APPLICATION: DM/26/1597

PROPOSAL: RETROSPECTIVE APPLICATION TO RAISE LAND LEVELS TO CREATE A LEVELLED GARDEN AND INSTALL PATIO (UPDATED PLANS RECEIVED AND DESCRIPTION AGREED ON 11.09.2026)

SITE: 5 WILLIAM ALLEN LANE, LINDFIELD, HAYWARDS HEATH, WEST SUSSEX, RH16 2SA

Figure 1: Heights of the constituent parts of the land raising above ground level, in millimetres

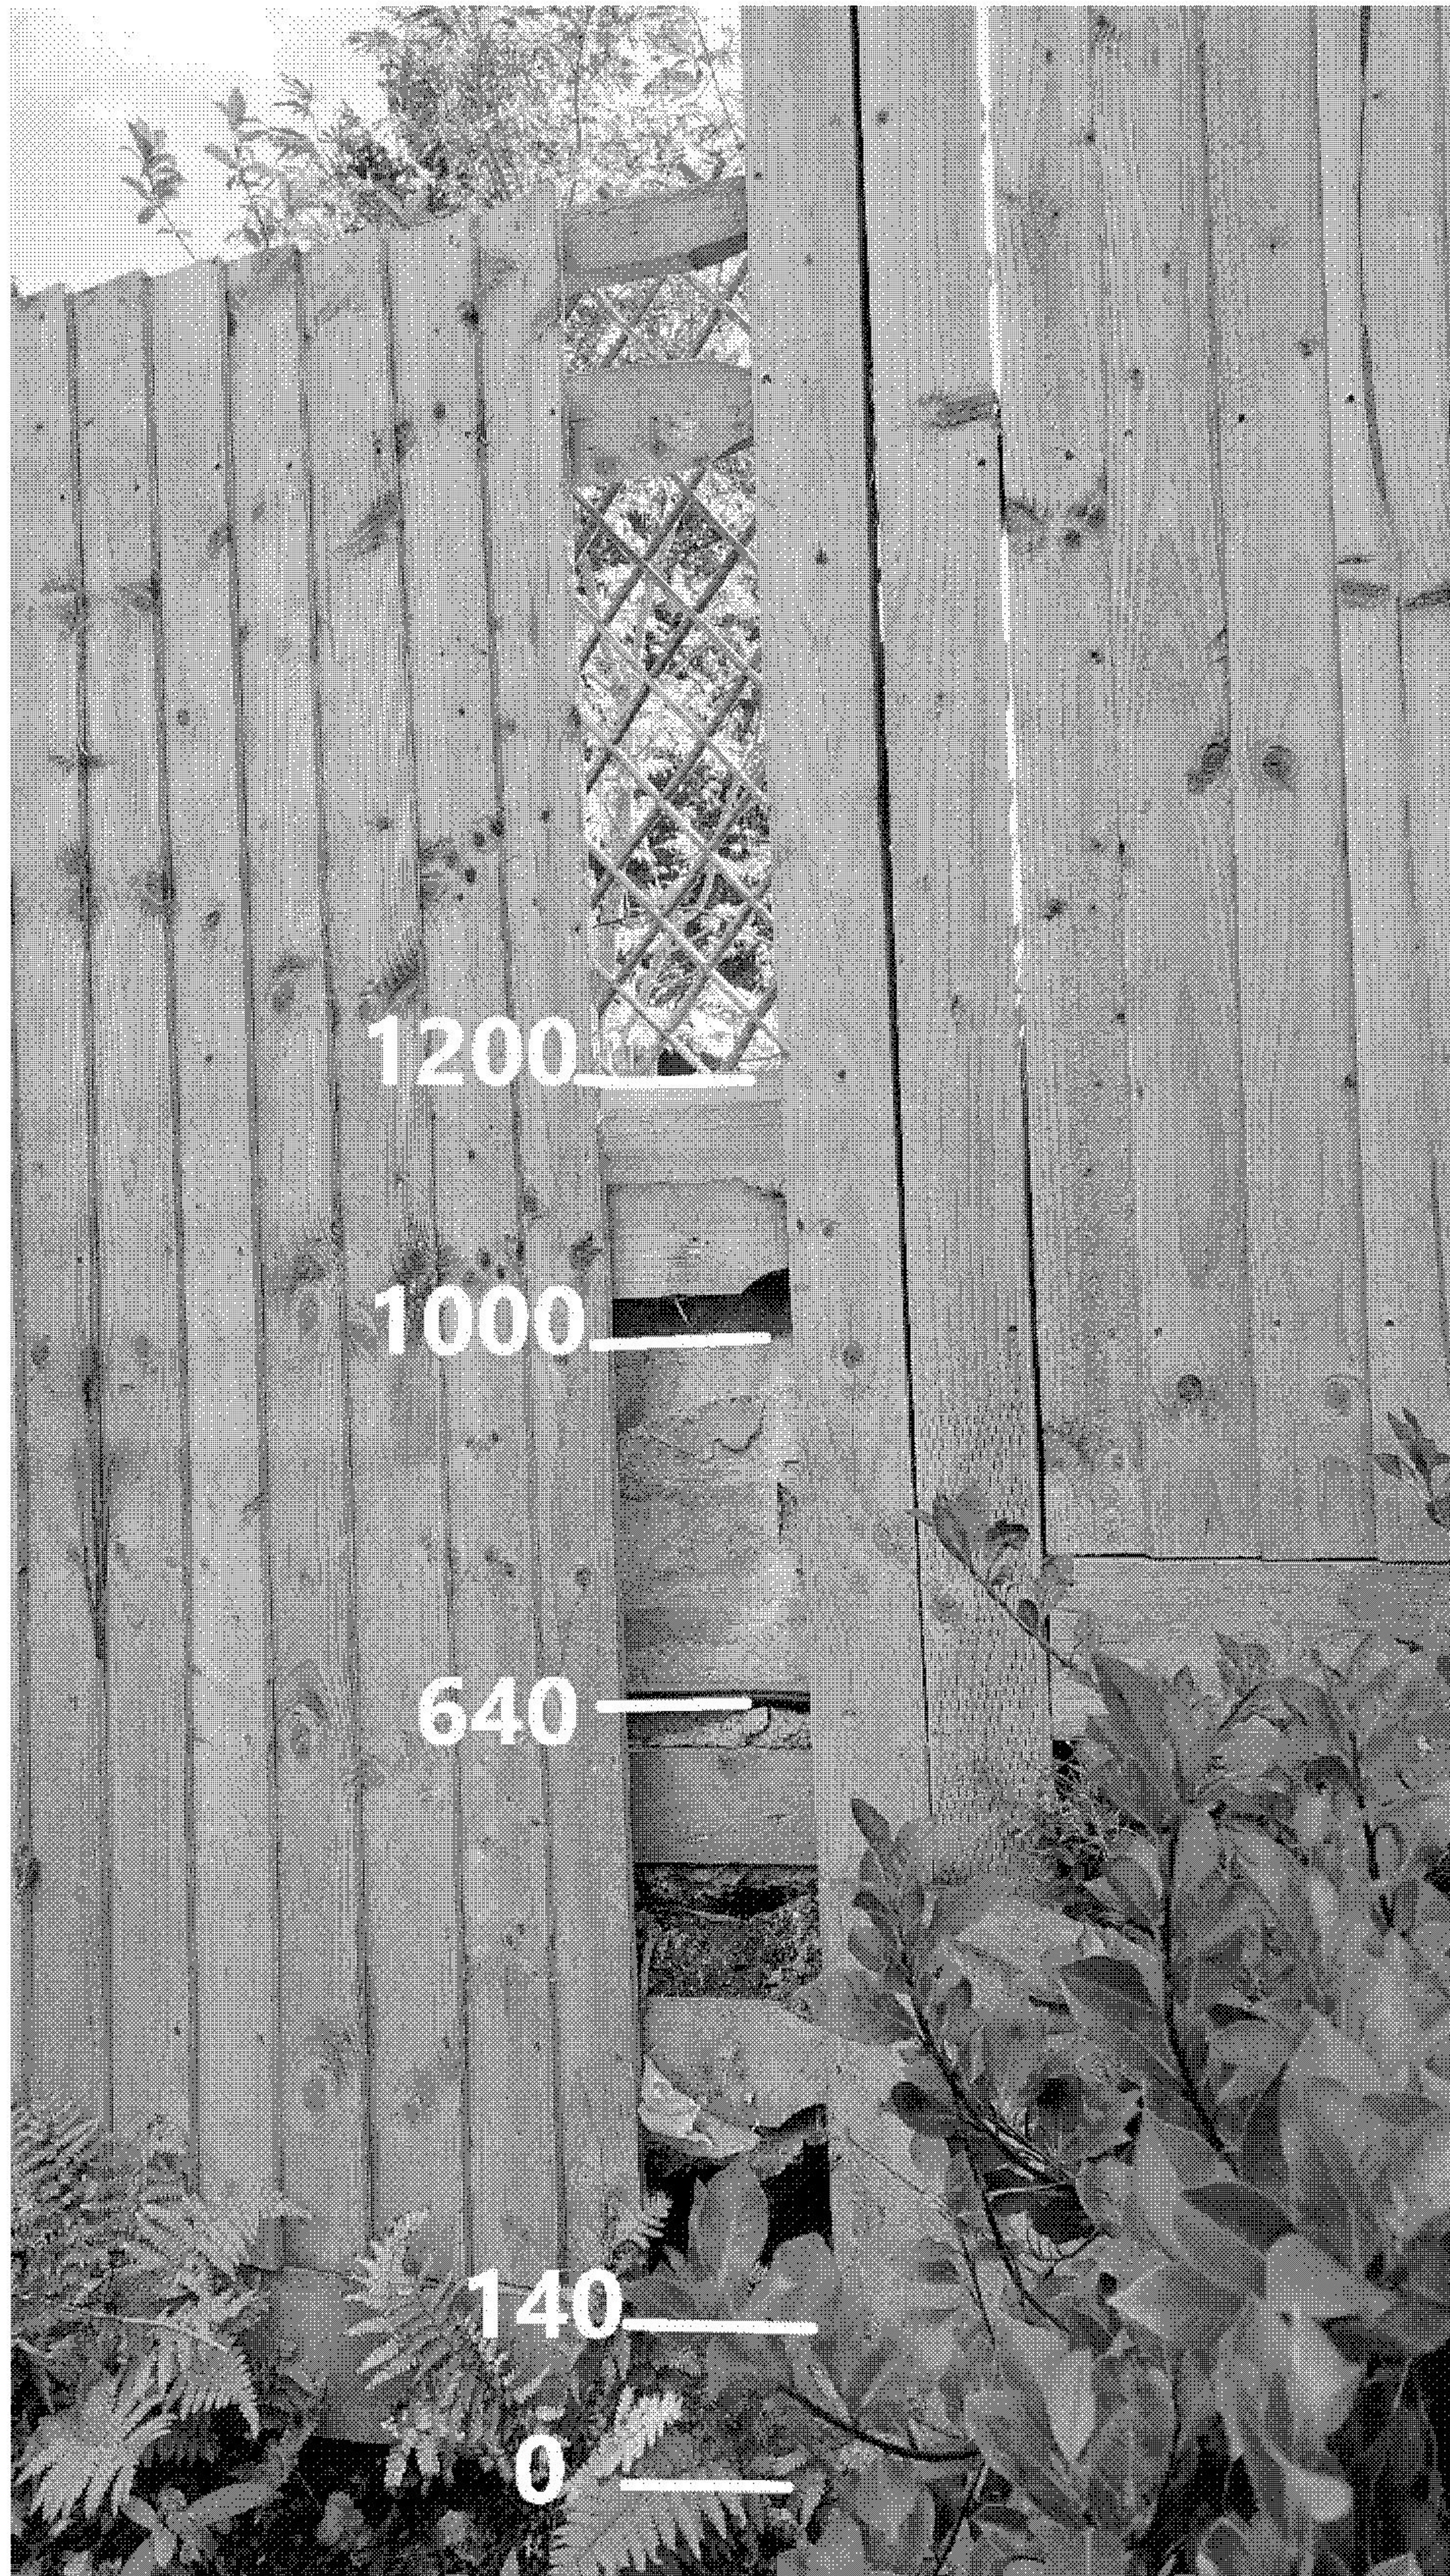
The removal of sections of fencing has exposed construction which was previously concealed and which is not adequately represented on the submitted section drawing. The photographs show soil and other material immediately behind the existing fence, together with timber boarding, concrete/mortar and the construction supporting the raised patio. Figure 1 shows the height above ground level of these constituent parts.

Figure 2 shows a worn piece of hardboard that has been wedged between the horizontal struts of my client's fence and the mix of soil and mortar that has been placed to fill the gap behind. This extends down to the very bottom of my client's fence, 1.2 metres *below* the level of the neighbour's new patio. The 1200mm measured does not correlate with the 640mm height increase shown on the submitted section plan.

Figures 3 and 4 show this horizontal timber board referred to in the report. The original fence supports are outlined in blue. The photograph shows that the upper timber board has been fixed to the *back* of the fence, and *below* the blue irrigation pipe (see Figure 1). This indicates that engineering operations have been undertaken at lower levels than indicated on the submitted section plan. Above the pipe there is a further 560mm of concrete, blockwork and patio pavers.

This reinforces our concern that the submitted section drawing does not provide sufficient information to understand the depth of engineering operations, their construction or the relationship between the original ground levels, the retaining construction and the finished levels.

Figure 3: Original parts of the fence (outlined in blue) and the horizontal board that has been fixed to the back of the fence (red)

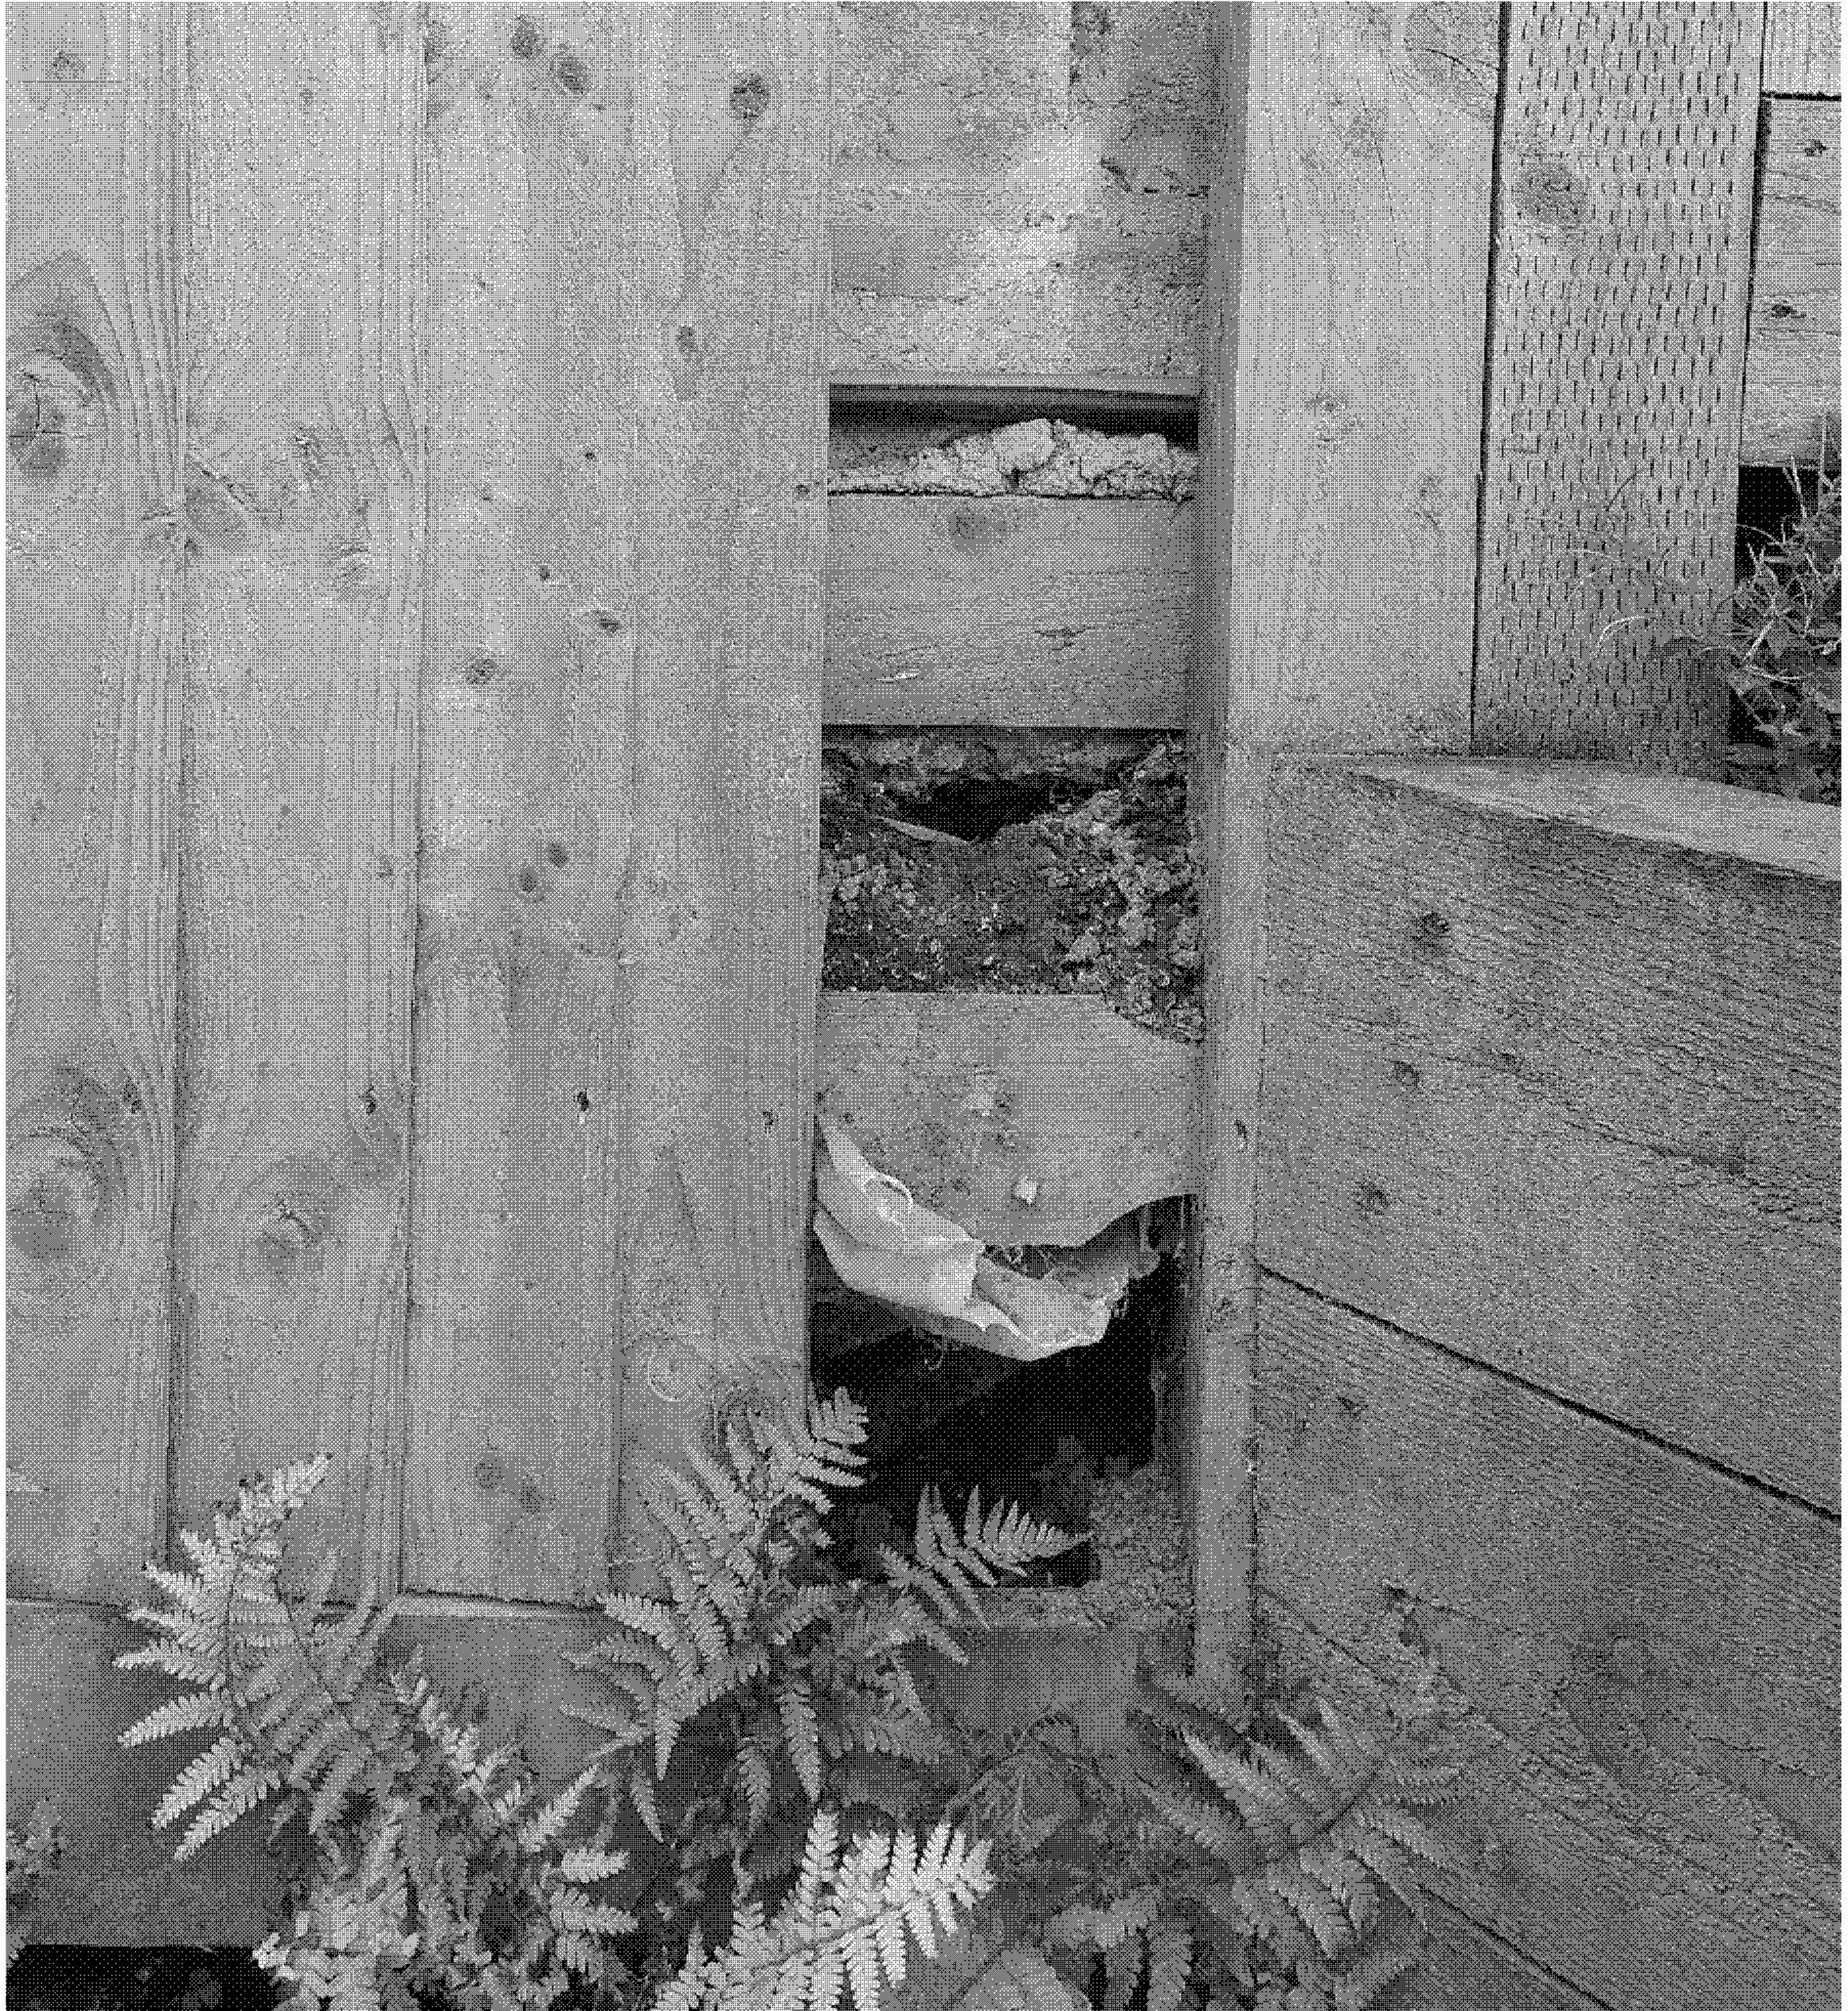
The Site Inspection Report confirms that the retaining wall and raised patio on the neighbouring property had been built directly against the existing boundary fence. This is illustrated in the enclosed photographs.

The fencing contractor measured the fence as being approximately 100mm out of plumb towards No. 7 and observed retained material in direct contact with its rear face. He considers the movement to be consistent with pressure being applied from the higher neighbouring side. He further advises that a normal close-boarded timber fence would not ordinarily be relied upon as part of a permanent retaining structure where there is approximately 1.1m difference in ground level. The inspection did not reveal any permanent retaining structure having been put in place at No 5.
